# HISTORIC AND DESIGN REVIEW COMMISSION

August 15, 2018

**HDRC CASE NO:** 2018-392  
**ADDRESS:** 2242 W MISTLETOE  
**LEGAL DESCRIPTION:** NCB 6830 BLK 0 LOT E 30 FT OF 24 W 30 FT OF 25  
**ZONING:** R-6 H  
**CITY COUNCIL DIST.:** 7  
**DISTRICT:** Monticello Park Historic District  
**APPLICANT:** Daniel Garcia  
**OWNER:** Ramona Cardenas  
**TYPE OF WORK:** Window replacement  
**APPLICATION RECEIVED:** July 27, 2018  
**60-DAY REVIEW:** September 21, 2018

The applicant is requesting a Certificate of Appropriateness for approval to replace six (6) existing aluminum windows with new vinyl windows.

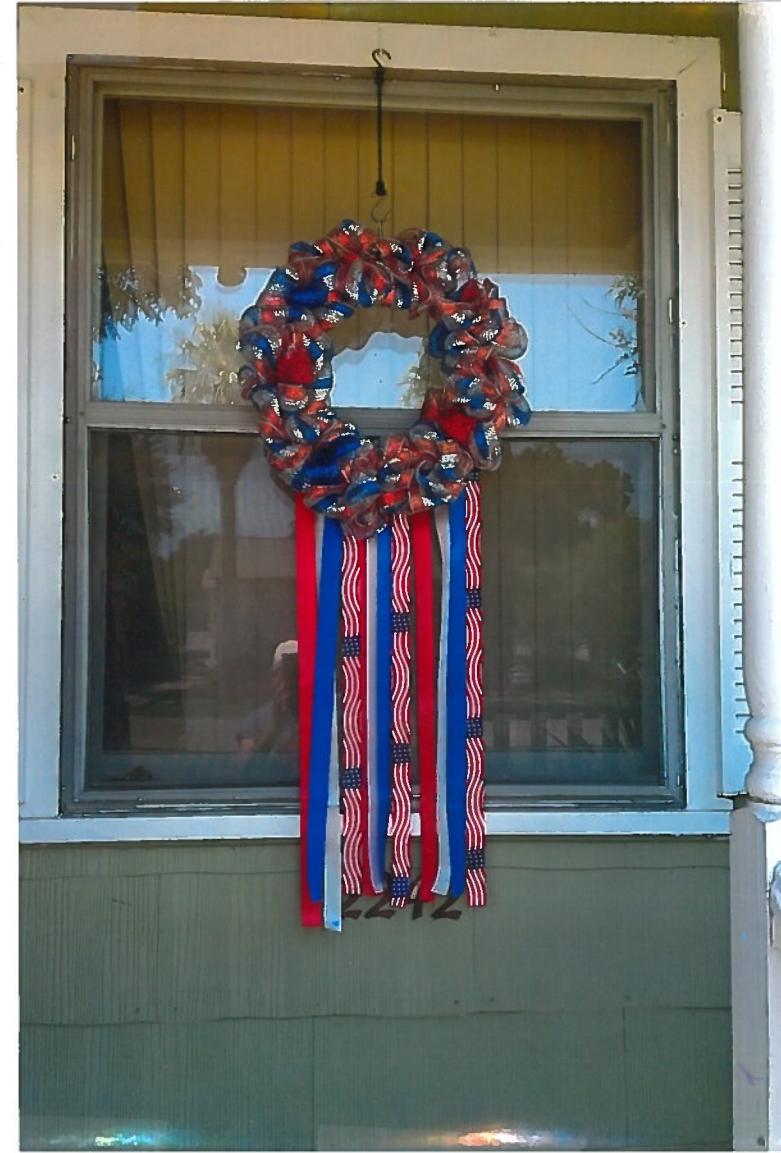
- b. **ALUMINUM WINDOW REPLACEMENT** – The applicant is requesting approval to replace non-original aluminum windows with one over one vinyl windows with faux divided lites on the top sash. The existing aluminum windows are not appropriate for the style of the home in terms of profile, inset, and dimensions. According to the Historic Design Guidelines, non-historic incompatible windows should be replaced with windows that are typical of the architectural style of the building. Staff finds that vinyl windows may be appropriate for replacing incompatible aluminum windows if the windows meet all the required specifications listed in the recommendation. At this time, the windows submitted for approval in the HDRC application are not appropriate.

- i. That the windows be a one over one configuration and do not feature faux divided lites.
- ii. That a final window manufacturer specification be submitted to staff for review and approval and meet the following stipulations: that meeting rails be no taller than 1.25" and stiles no wider than 2.25". White is not allowed, and color selection should be presented to staff. There should be a minimum of two inches in depth between the front face of the window trim and the front face of the top window sash. This must be accomplished by recessing the window sufficiently within the opening. Window trim must feature traditional dimensions and architecturally appropriate sill detail. Window track components must be painted to match the window trim or concealed by a wood window screen set within the opening.
